Calvert Cliffs Nuclear Power Plant, Units 1 and 2
Renewed Facility Operating License Nos. DPR-53 and DPR-69
Docket Nos. 50-317 and 50-318

Subject: August 2014 Six-Month Status Report in Response to March 12, 2012
Commission Order Modifying Licenses with Regard to Reliable Spent Fuel Pool
Instrumentation (Order Number EA-12-051)

SIX-MONTH STATUS REPORT (AUGUST 2014)
FOR RELIABLE SPENT FUEL POOL INSTRUMENTATION

Response to
Request for Additional Information
From
Interim Staff Evaluation on Reliable Spent Fuel Pool Instrumentation
Dated November 15, 2013
Calvert Cliffs Nuclear Power Plant, Units 1 & 2
Docket Numbers 50-317 and 50-318

Figure 1.1, CCNPP Spent Fuel Pool Elevation View Sketch

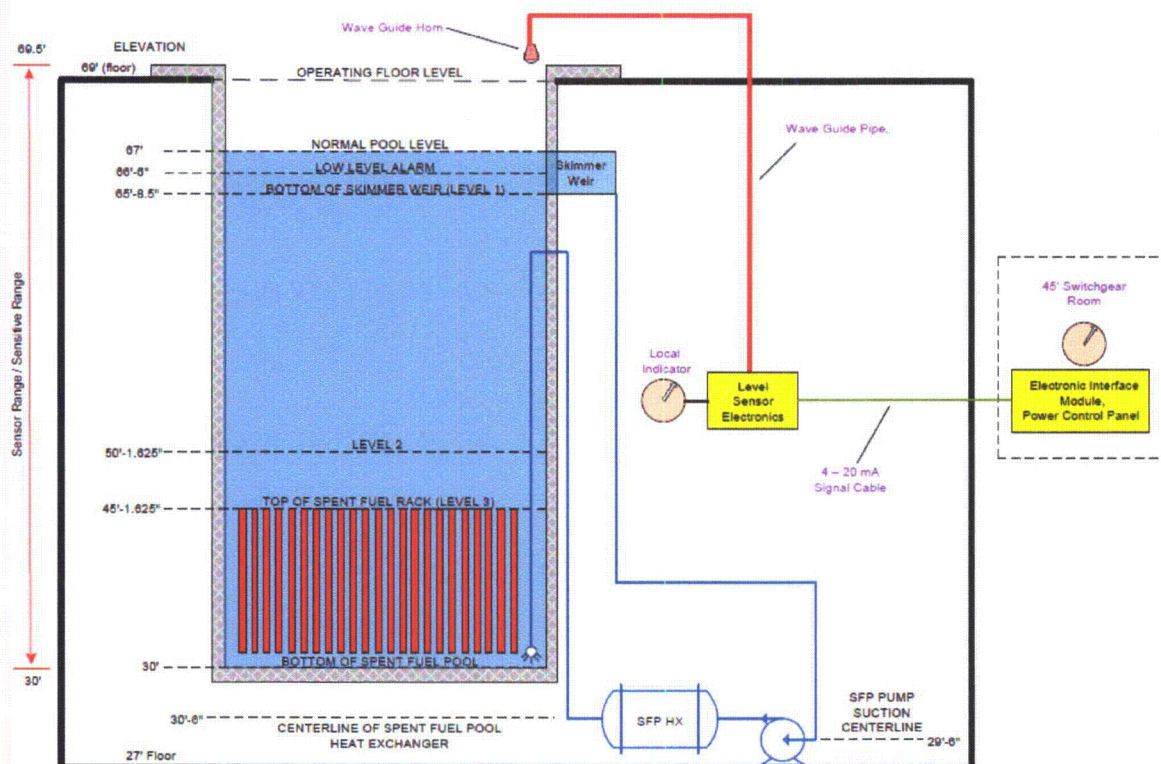
*For Level 1, please specify how the identified location represents the **HIGHER** of the two points described in the NEI 12-02 guidance for this level.*

As indicated in Figure 1.1, CCNPP designated Level 1 to be at the 65 foot 8.5 inch level of the spent fuel pool. This level corresponds to the bottom of the spent fuel pool skimmer weir, 3 inches below the low water alarm setpoint. Level 1 is selected to ensure that a void will not occur in the suction lines. Analysis has demonstrated that there is adequate NPSH for pump operation at saturated conditions for water at Level 1.

Thus Level 1 is the higher of the two pump-limiting conditions specified in NEI 12-02.

Figure 3.2, Unit 2 Back-up Level Cable Route

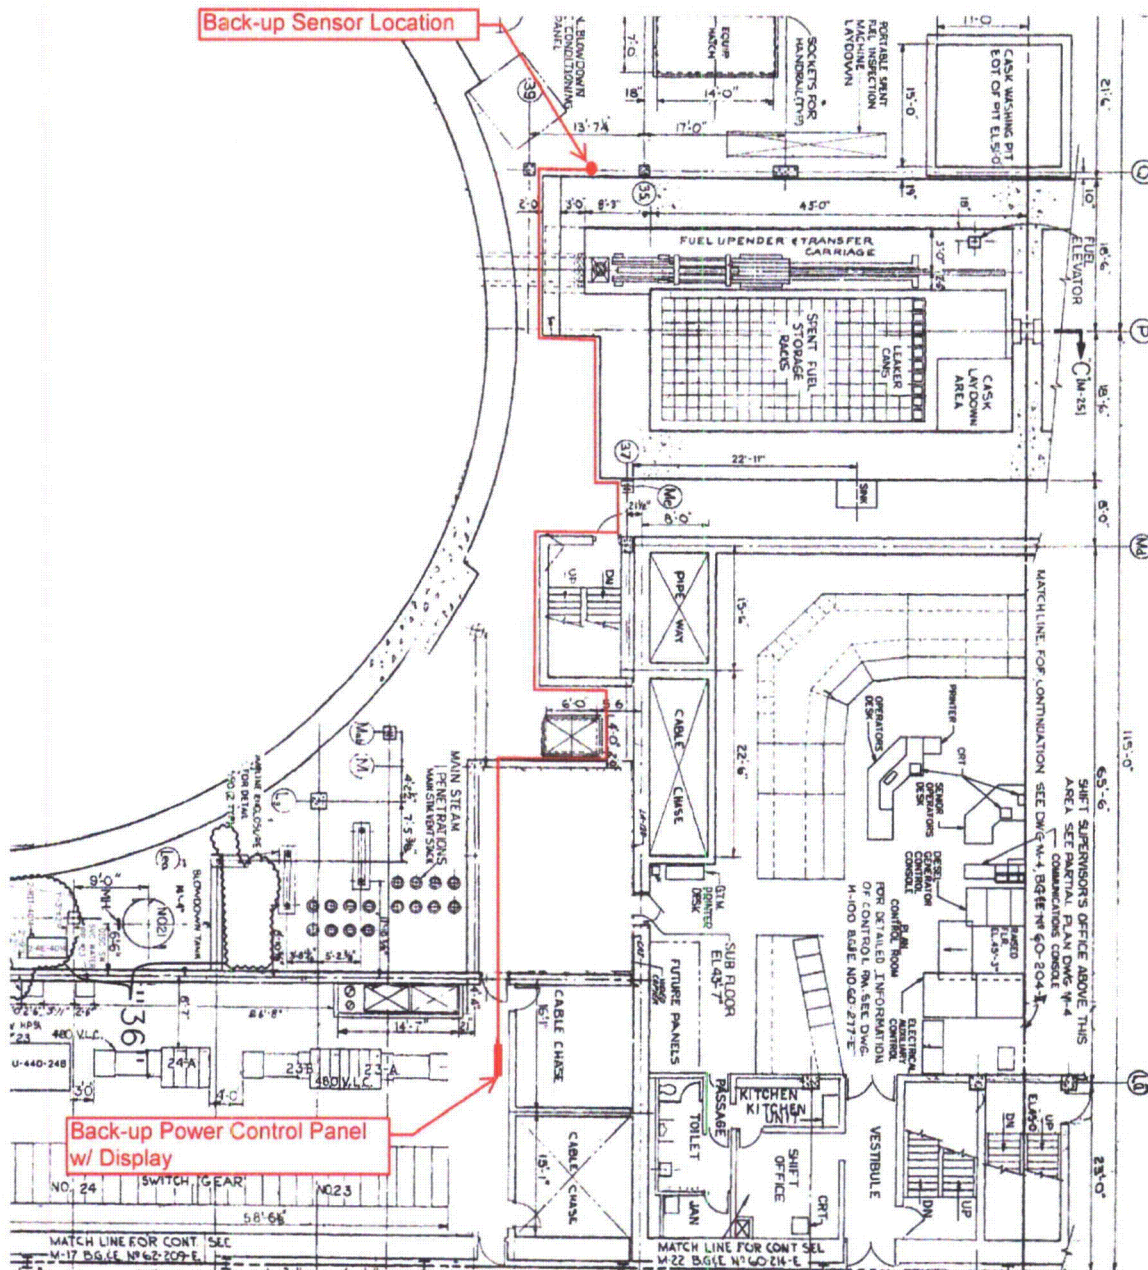
Please provide additional information describing how the proposed arrangement of the conduit and routing of the cabling between the spent fuel and the location of the read-out/display device meet the guidance to arrange the SFP level instrument channels in a manner that provides reasonable protection of the level indication function against missiles that may result from damage to the structure over the SFP.

There are no cables or conduit routed in the SFP area for this installation, but rather a waveguide antenna horn and approximately 8 feet of waveguide antenna tubing for each channel. The waveguide horns are mounted at opposite ends of the SFP and therefore physically separated to preclude missile damage to both channels. The SFP is a seismic Category I structure; therefore, in the SFP area above the pool, all equipment is required to meet Seismic II/I mounting requirements to ensure it does not fall and create a missile during a seismic event equal to the design basis of the SFP.

See Figures 3.1 and 3.2 for primary and back-up channel cable and conduit routing between the sensor and the display panel for each channel. As can be seen in the figures, each route is physically separated from each other to prevent a missile from damaging both channels.

Figure 14.1, Primary Channel Power Supply Source 1L12

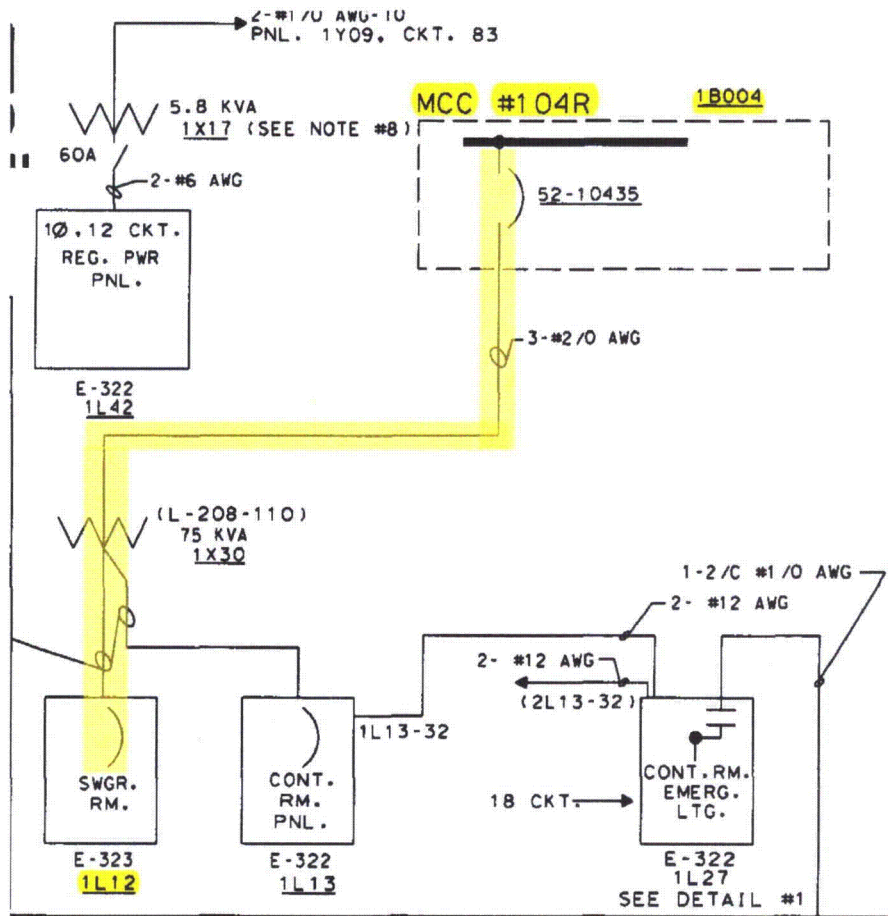
Please provide the NRC staff with the final configuration of the power supply source for each channel so that the staff may conclude that the two channels are independent from a power supply assignment perspective.

The primary channel receives normal AC power from Unit 1 lighting panel 1L12 while the back-up channel receives power from Unit 2 lighting panel 2L07. Figures 14.1 and 14.2 are marked-up single line diagrams identifying the upstream source for each channel. As can be seen, each channel is powered from an independent AC source during normal operation. Normal power supply to the primary SFP Wide Range Level Indicator (WRLI) is from a Unit 1 motor control center (MCC) and the backup SFP WRLI is from a Unit 2 MCC; however, during an ELAP power is automatically transferred to a battery backup within each of the power control panels. This feature was tested during the Factory Acceptance Test and was satisfactory. The loss of AC power test will be performed on site during the Site Acceptance Test following completion of field implementation activities.
